Supplement #3

THE FINAL SUPPLEMENT TO THE
"ENGINEERING EVALUATION OF THE WNP-2
SACRIFICIAL SHIELD WALL" SUBMITTED TO NRC
IN AUGUST 1980

Table III.D.5

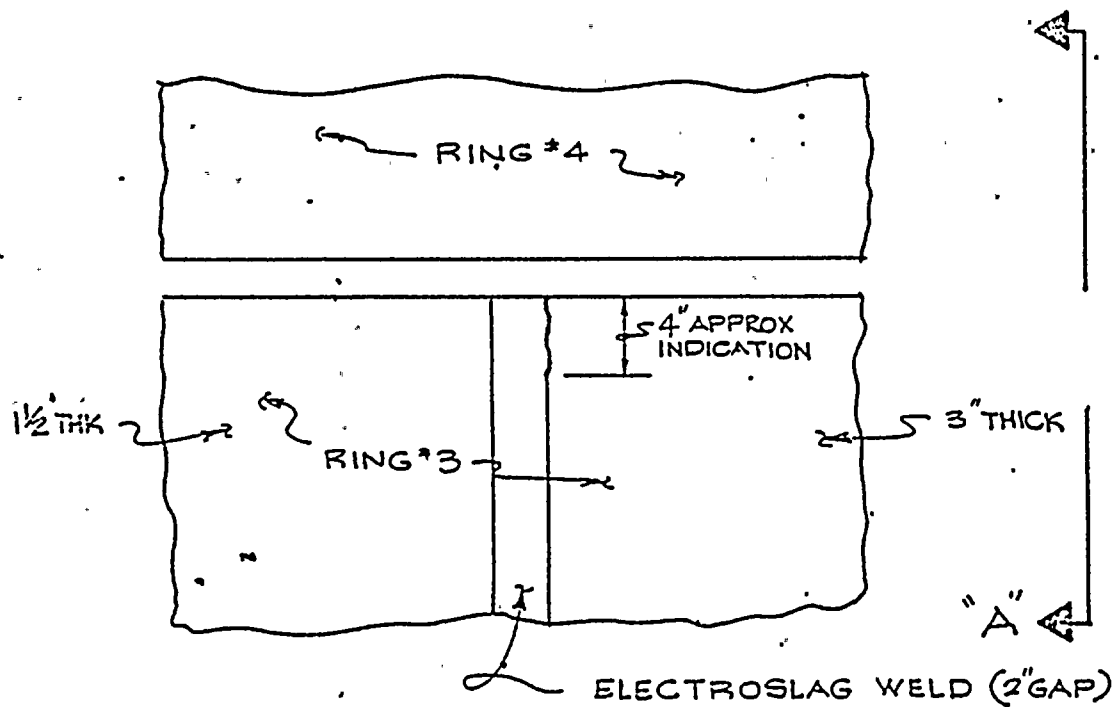
Table III.D.5, attached, is revised, reflecting the 1/4" incomplete penetration, and a corrected typographical error for undercut.

FIG 1. LINEAR INDICATION IN RING 3 AT 135°-150° AZ

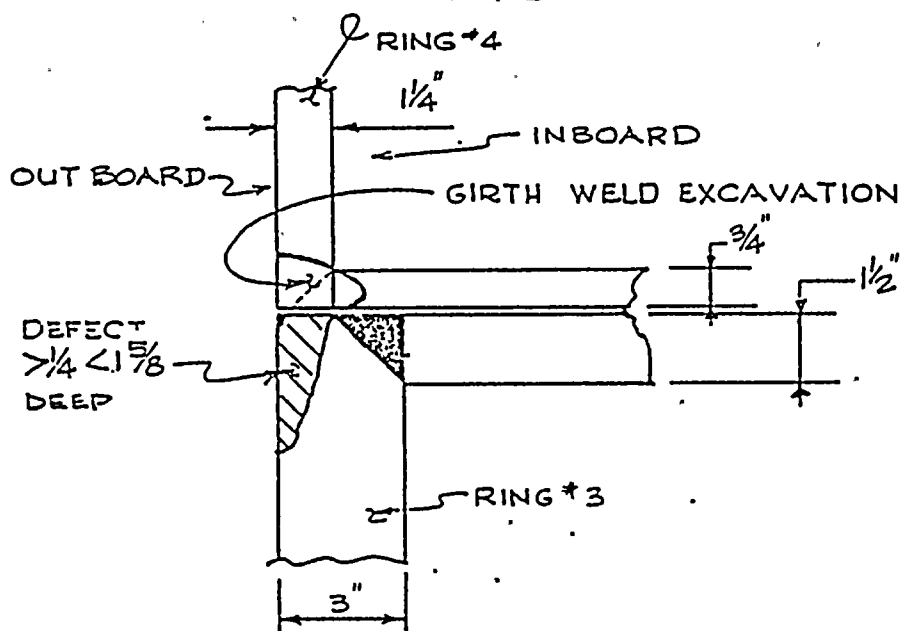
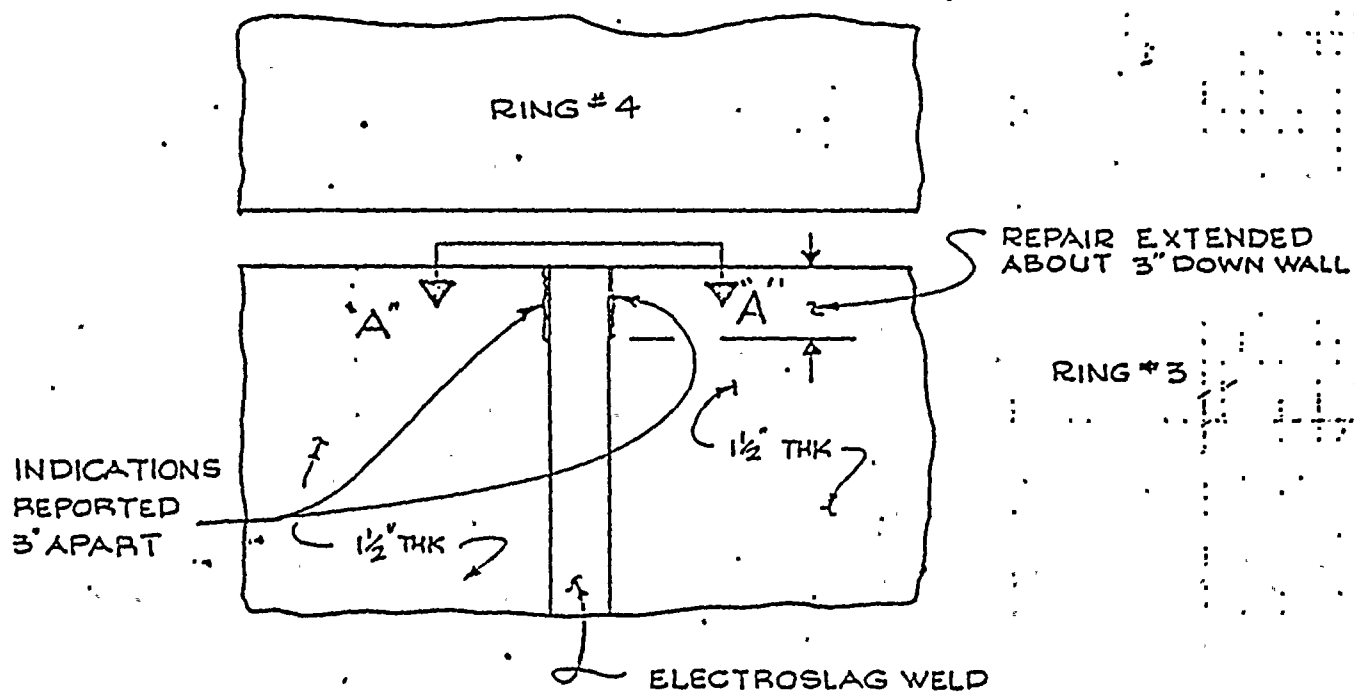
- (i) Linear indications in electrosag welds were discovered adjacent to the girth weld. Details of this deficiency are given in Figures 1 and 2. This deficiency was detected in two of the thirty-two electrosag welds in ring #3 which intersect the girth weld.
- (ii) Linear indications, slag inclusions and porosity were discovered in guide plate welds (see Figure 3).
- (iii) Lack of penetration existed at the weld joint between the bottom flange of ring beam #4 and the exterior web plate. Details of this deficiency are shown in Figure 4. For further discussion and clarification see Part 5.
- (iv) Linear indications in the girth weld excavation probably resulted from the repair of deficiency (iii) above.

These deficiencies are discussed in detail in Ref. 11. It is concluded that the nature and severity of the deficiencies observed during the girth weld repair are bounded by the assumptions of Ref. 1 and that their discovery does not influence the conclusions of Ref. 1 with respect to the integrity of the SSW under design loading conditions.

FIG. 4. LACK OF PENETRATION AT AZ. 90°-105°, 0°-15°, AND 180°-195°.

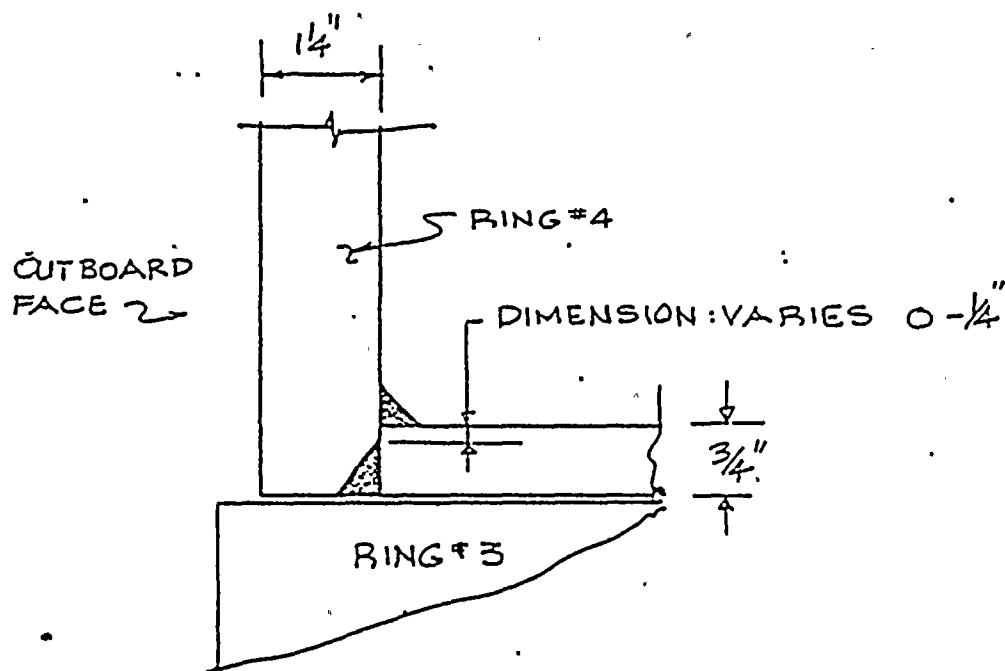
5.1 The Engineering Evaluation of the WNP-2 Sacrificial Shield Wall Supplement No. 2, Part II.C identified three locations where incomplete penetration (I.P.) was discovered in the partial penetration flange-to-web plate weld on ring 4. (See Figure 4 of this supplement). The incomplete penetration identified was 1/4" deep; however, the original report addressed 5/32" as the worst I.P. case in Table III D.5.

In comparing the a/t ratio of 0.33 for the 1/4" I.P. in 3/4" thick material to Table III.D.2, there are no a/t ratios in either the static loading or the dynamic loading columns for any of the materials equal to 0.33. Therefore, plastic collapse will not occur. An a/t ratio greater than 0.5 would have to occur before plastic collapse could occur.

In addition, the potential for plastic collapse is reduced by the design of the SSW. For plastic collapse to occur, large strains and displacements are required. The SSW is a redundant structure in that loads are transmitted through many members in parallel. The displacement which can be applied to a weld joint is limited by parallel joints. The design and the evaluation for plastic collapse leads to the conclusion that the 1/4" I.P. will not cause plastic collapse and is enveloped by the original assessment of the wall.

FIG. 5 TRANSVERSE MACROSECTION THROUGH ELECTROSLAG WELD
P.W. 254M # 4

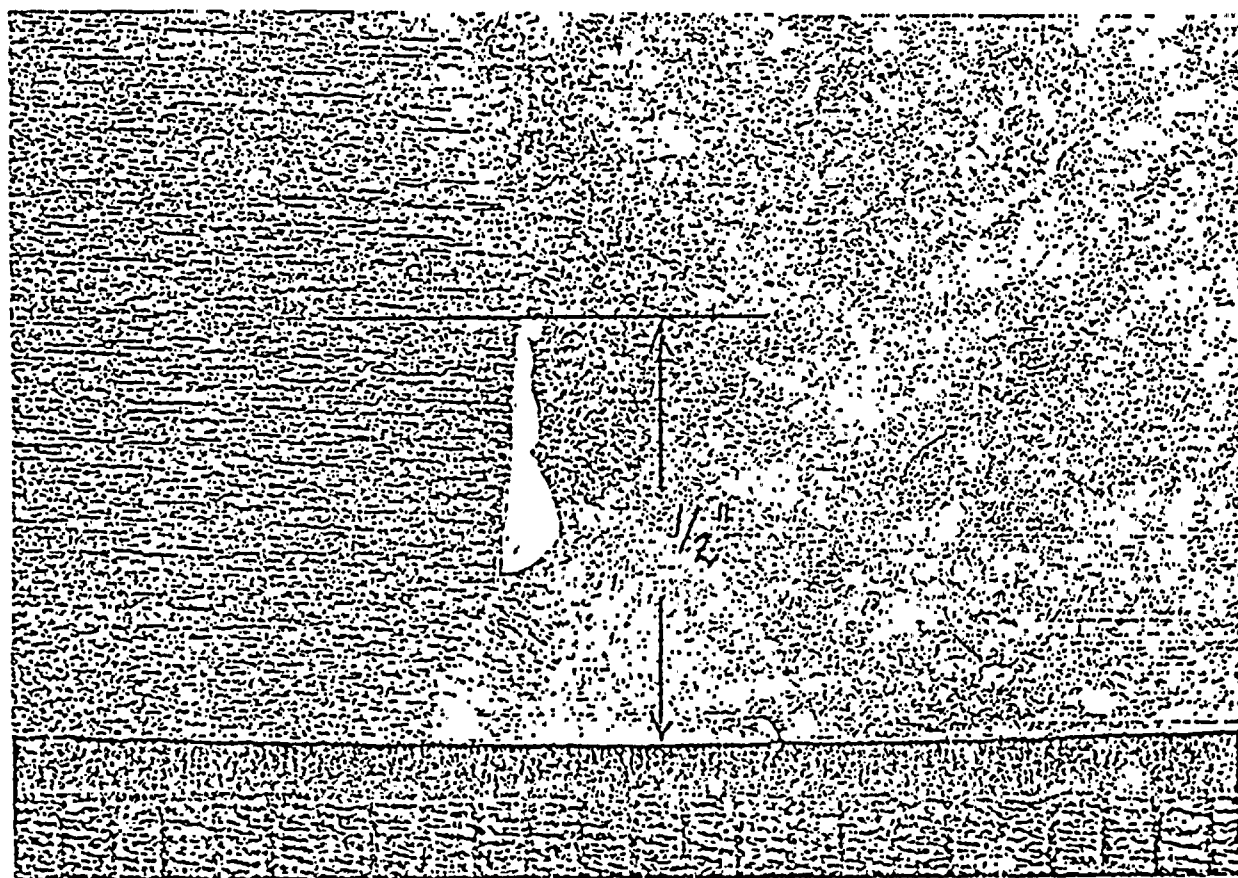
Prior to machining drop weight test plates, the sample was examined by UT and sectioned for macroscopic examination. A subsurface defect was found which extended along the length of the sample. The nature and extent of the defect is shown in Figure 5. It consists of a lack of fusion defect on the sidewall of the weld which originally extended in from the surface of the weld, but was partially excavated and repaired.

In addition, two similar, but shallower defects were observed on the other side of the weld (Figure 5).
